Company	Trenz Electronic GmbH
PCN Number	PCN-20190830
Title	TEI0009-02 Under Voltage Protection Change
Subject	Trenz Electronic TEB0724 Hardware Change
Issue Date	2019-09-05

This change affects TEI0009-02 with serial numbers greater than A14909.

### #1 Replaced R27 by 953kOhm and R32 by 147kOhm

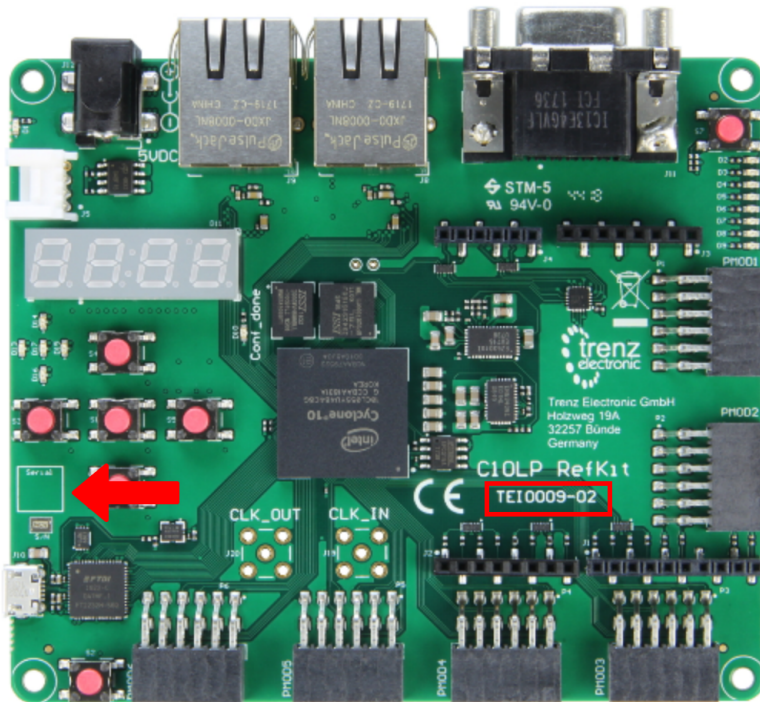
**Reason:** Large start up currents led due to adverse conditions (e.g. weak powersupply, long wires, increased contact resistance) to a voltage drop below the under voltage lock out limit of the input protection circuit.

**Impact:** Under voltage protection limit is decreased to 4.06V, which gives a larger margin for a voltage drop during start up.
